ADDENDUM NO. 4

THIS ADDENDUM FORMS A PART OF THE CONTRACT DOCUMENTS AND HEREBY MODIFIES THE ORIGINAL CONSTRUCTION DOCUMENTS DATED OCTOBER 18, 2021 RESPECTIVELY.

Lauderdale County
Government Building

SHEET TITLE
OVERALL FIRST & SECOND
FLOOR REFLECTED CEILING
PLAN & NOTES

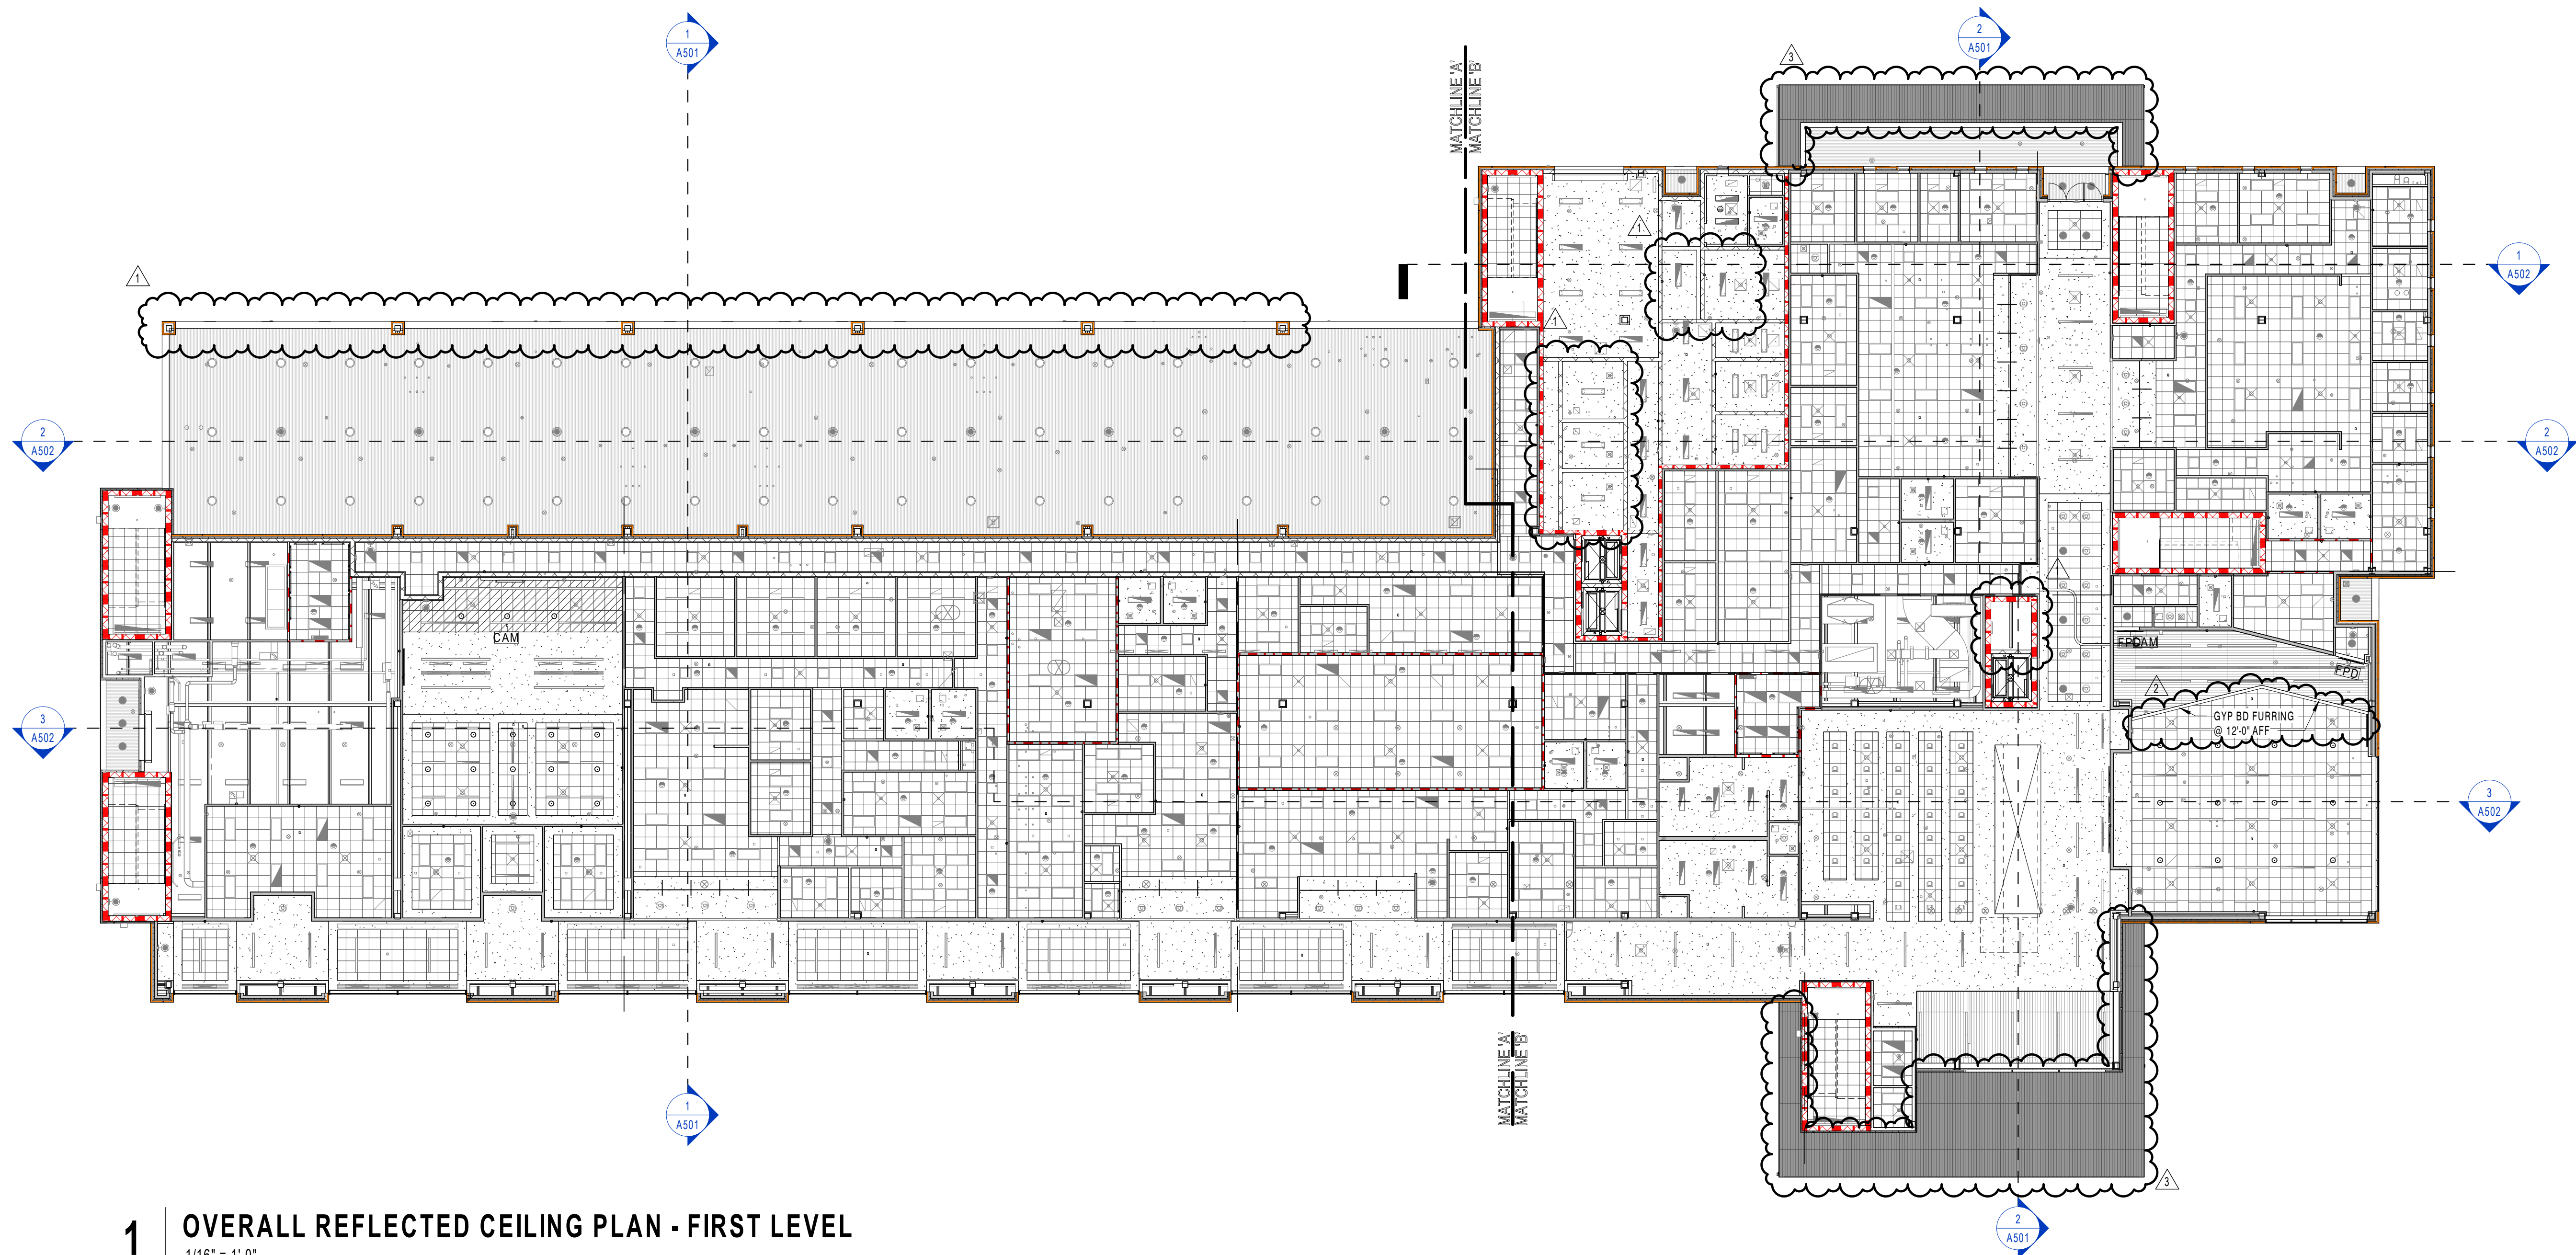
Item #14 SECTION 095123 ACCOUSTICAL TILE CEILINGS

REVISE: Section 2.3 ACOUSTICAL TILES – STANDARD A. Basis-of-Design

Product: Subject to compliance with requirements, provide 24" x 24" x 5/8" non-directional fissured Ultima Tegular 1902 by Armstrong World Industries, Inc. to Section 2.3 ACOUSTICAL TILES – STANDARD A. Basis-of-Design Product: CertainTeed BET/154 reveal or equal.

1 CHW SYSTEM CONTROL SCHEMATIC
M704 NO SCALE

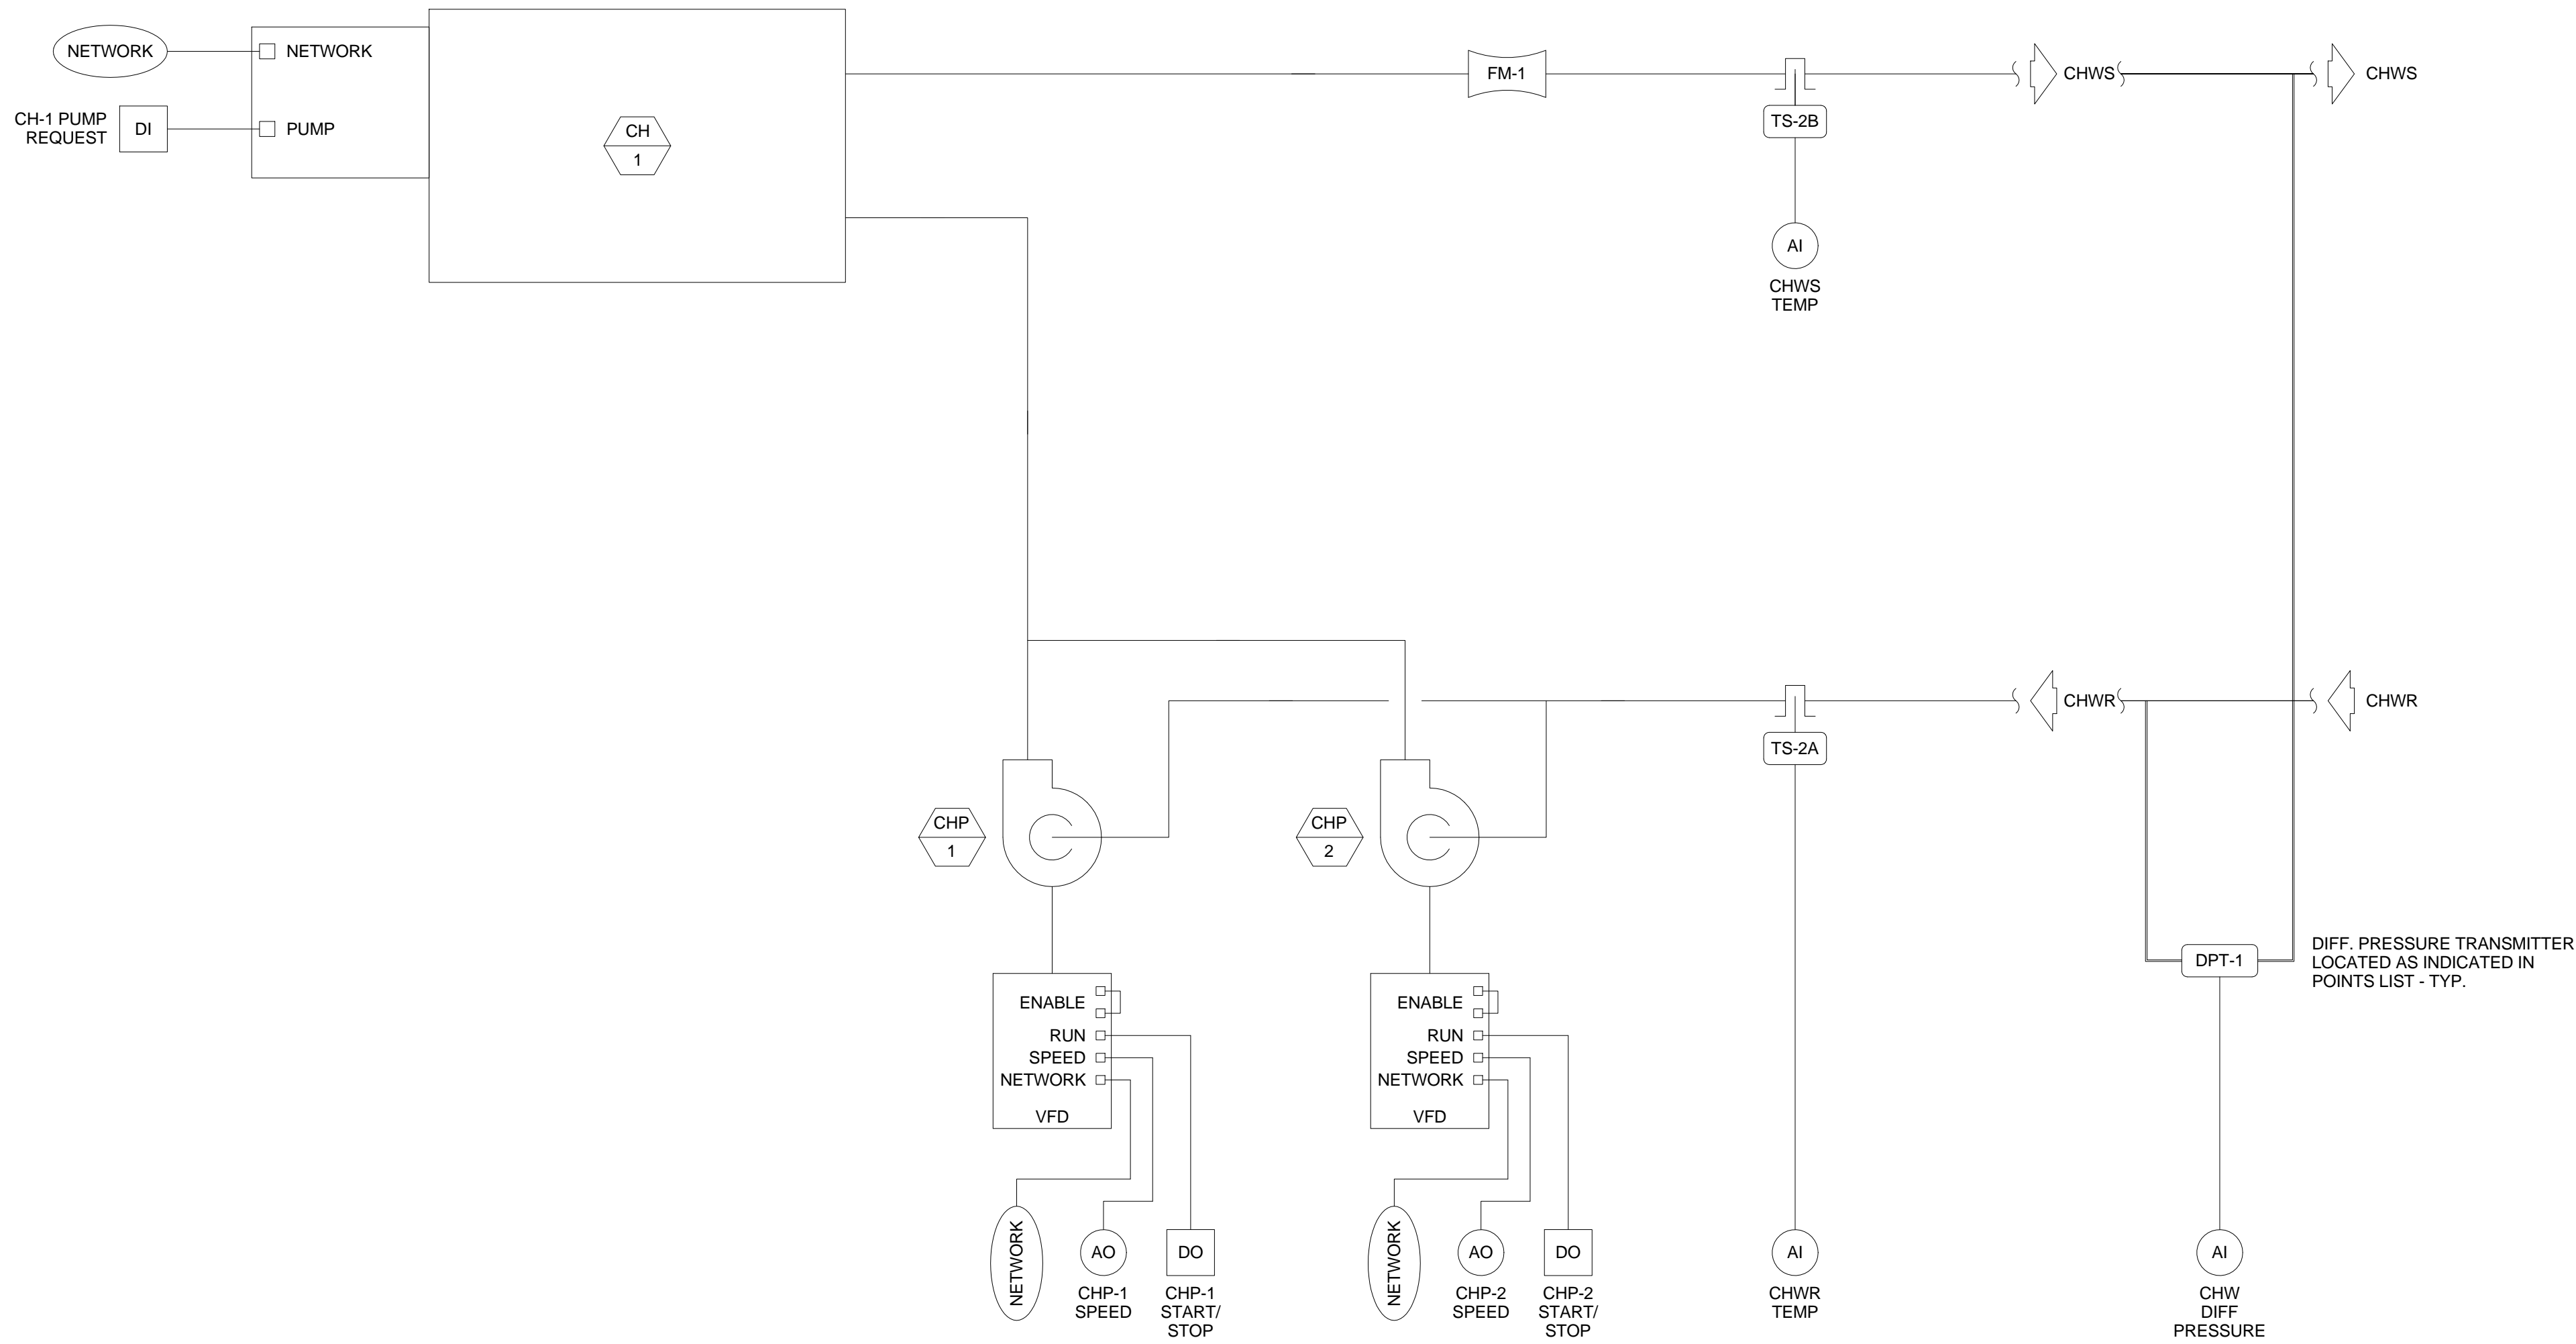
- Item #28 SHEET M118 – SECOND FLOOR PLAN – HVAC (RETURN/EXHAUST) – PART B**
REPLACE: Sheet M118 - Revision No. 2 (Addendum No. 4) dated 11/24/2021
- Item #29 SHEET M704 – HVAC CONTROLS**
ADD: Sheet M704 - Revision No. 2 (Addendum No. 4) dated 11/24/2021
